## PT1000 as replacement for KTY: Required servo inverter settings

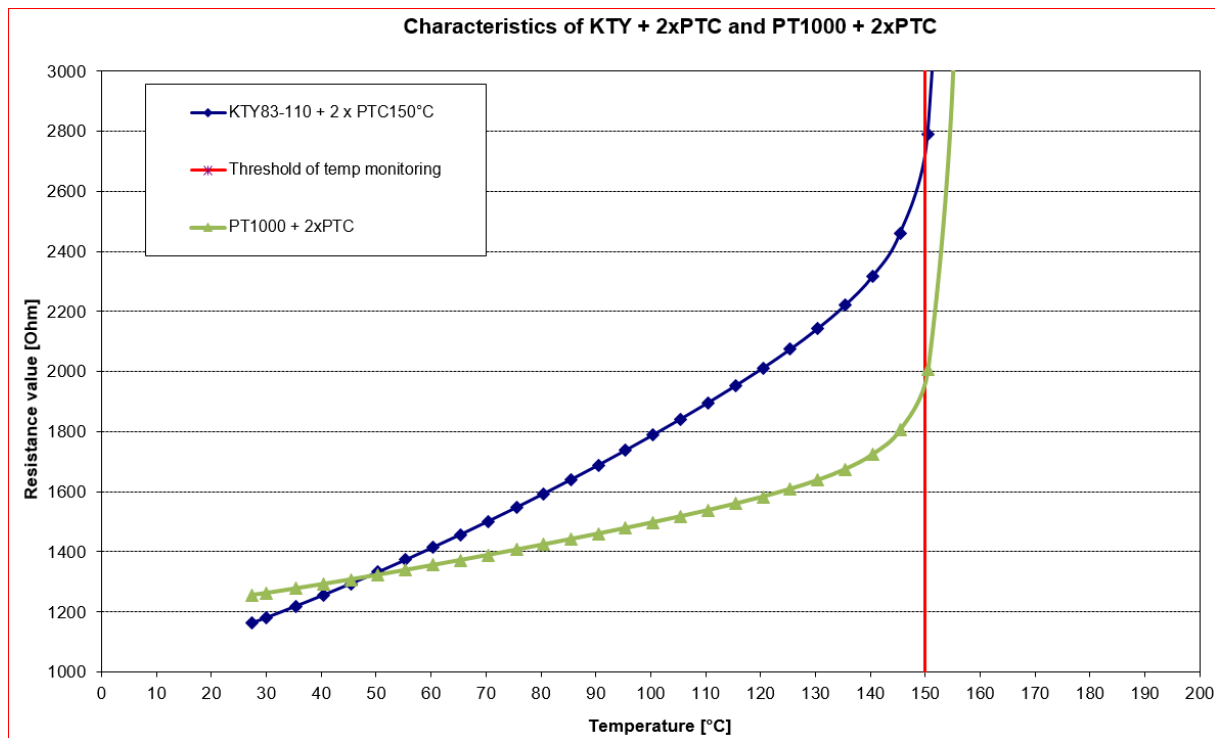
Use case 'Existing parameter set -> new motor'

- ⇒ If a KTY is parameterised in the inverter, but a PT1000 is installed in the motor, at temperatures from 50 °C, the temperature evaluation in the inverter will be increasingly too low and **a disconnection at 150 °C is not ensured; the motor may overheat!**

Use case 'Parameter set adapted to PT1000 -> old motor from warehouse'

- ⇒ If a PT1000 is parameterised in the inverter, but a KTY is installed in the motor, **the temperature monitoring in the inverter will trigger too early**; at approx. 90 °C and not, as expected, at 150 °C. I.e. the availability of the machine is not ensured.

In torque-setting applications, the temperature error is 1:1 reflected in the controlled torque.

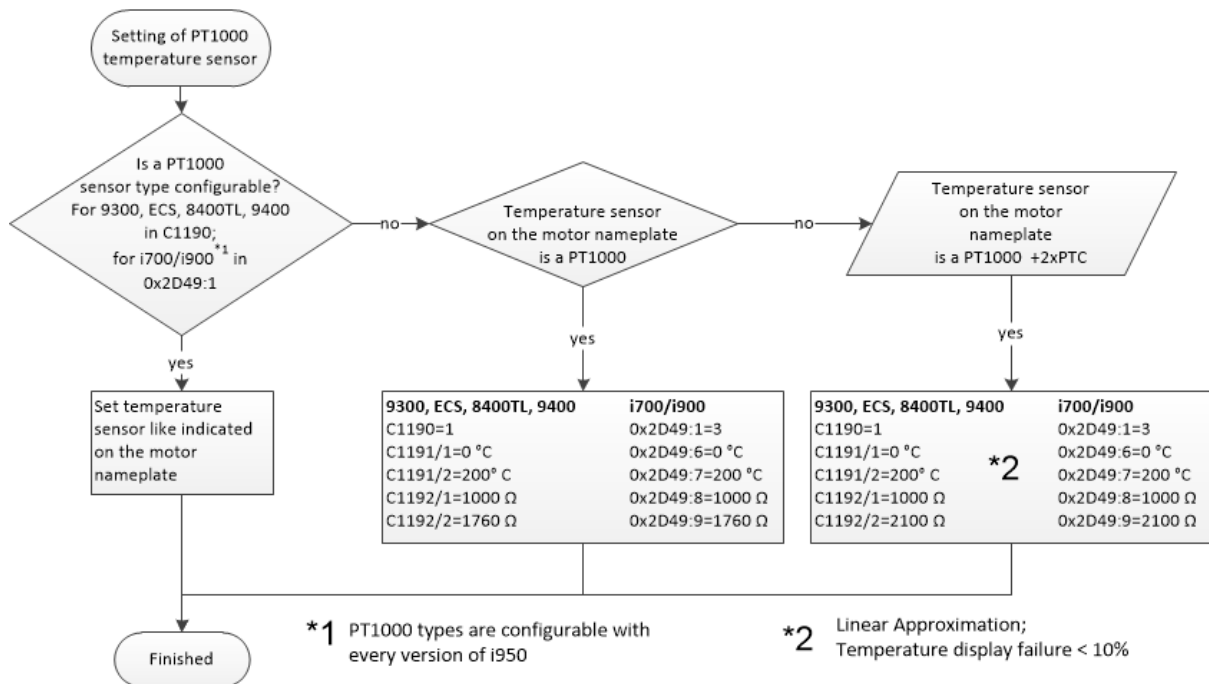
Use case 'Existing parameter set -> new motor'

- ⇒ If a KTY + 2xPTC is parameterised in the inverter, but a PT1000 + 2xPTC is installed in the motor, at temperatures from 50 °C, the temperature evaluation in the inverter will be increasingly too low and, in the event of a motor overload, the temperature monitoring in the inverter will trigger with a slight delay at approx. 155 °C instead of, as expected, at 150 °C.

Use case 'Parameter set has been adapted to PT1000 + 2xPTC -> old motor from warehouse'

- ⇒ If a PT1000 + 2xPTC is parameterised in the inverter, but a combination of KTY + 2xPTC is installed in the motor, the temperature monitoring in the inverter will trigger too early; at approx. 120 °C and not, as expected, at 150 °C. I.e. the availability of the machine is not ensured.

In torque-setting applications, the temperature error is 1:1 reflected in the controlled torque.

Applications with high torque-accuracy requirements using motors with a PT1000 + 2xPTC combination (MCS09 ... 19 and m850) as temperature sensors should no longer be used together with servo inverters that do not support this temperature sensor combination. If necessary, the firmware has to be updated by a Lenze engineer.

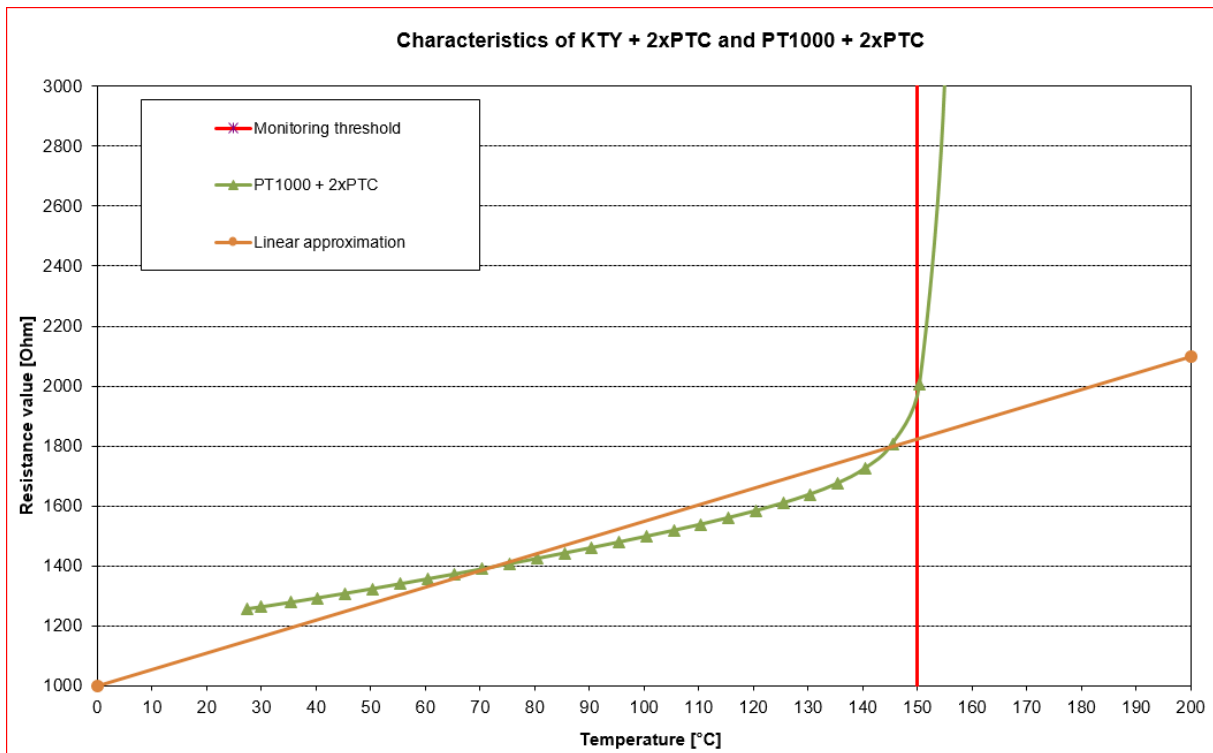
The combination of PT1000 + 2xPTC used in MCS09 ... 19 and m850 cannot be fully appropriately simulated by a linear approximation.

We propose to select a 'Linear approximation' as a compromise that will, on the one hand, ensure an overtemperature shutdown at >145 °C and, on the other hand, a temperature display error < 10% in the inverter in the typical operating range of the motor:

Temperature grid point 1 = 0 °C

Resistance grid point 1 = 1000 Ω

Temperature grid point 2 = 200 °C

Resistance grid point 2 = 2100 Ω
